TO: ALL ROOTES DEALERS

MODEL: SUPER MINX III, MINX V
(FLOOR GEAR CHANGE & BORG WARNER
MODELS ONLY)

SUBJECT: TRAFFICATOR SWITCHES

8069

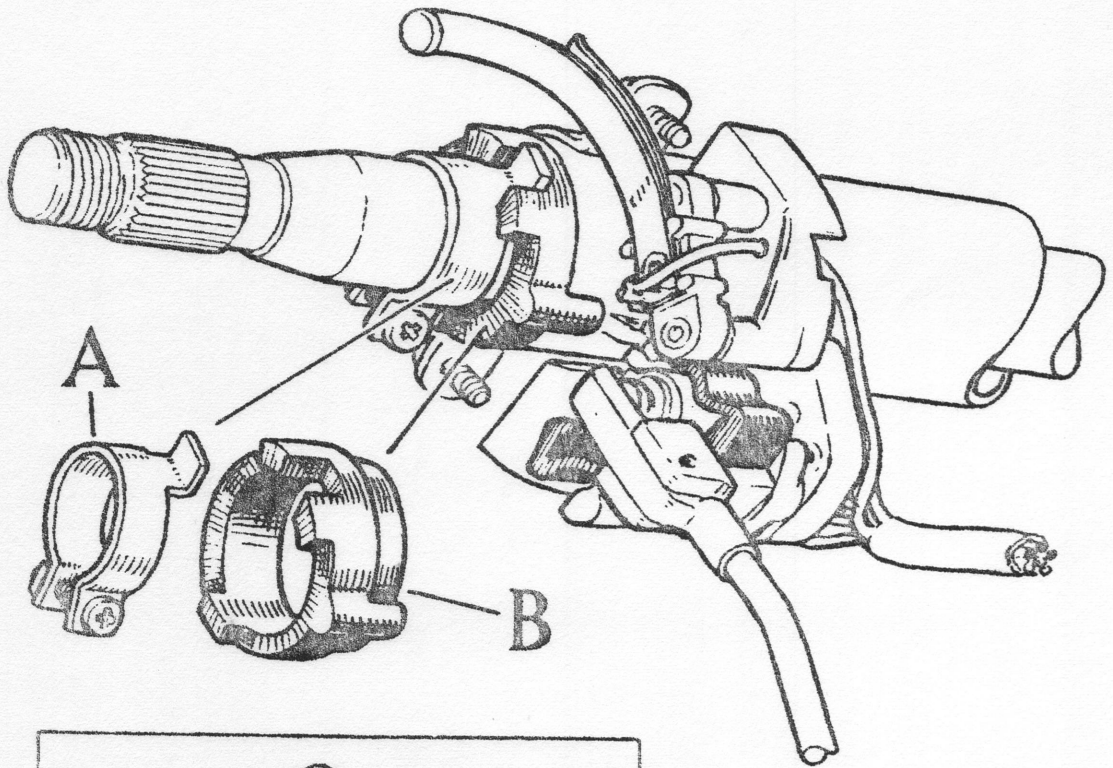
Within the Chassis Number range shown below, a modified type of trafficator switch striker was introduced.

This consists of a WHITE Delrin striker bush (B) positioned in the top of the outer column and a metal driving link (A) as shown on the accompanying illustration. The trafficator switch remains the same as previously fitted to these models.

Where difficulties are encountered with the trafficator switch mechanism on these cars, proceed as follows:-

1. Too shallow striker engagement giving lack of trip or too deep engagement causing trafficator to trip onto the opposite lock. DISCARD white Delrin striker bush (B) and metal driving link (A) and fit metal striker ring (C), Part Number 1229618.
2. Any other trafficator switch complaint, replace switch Part Number 1223746 or 1223747 as applicable.
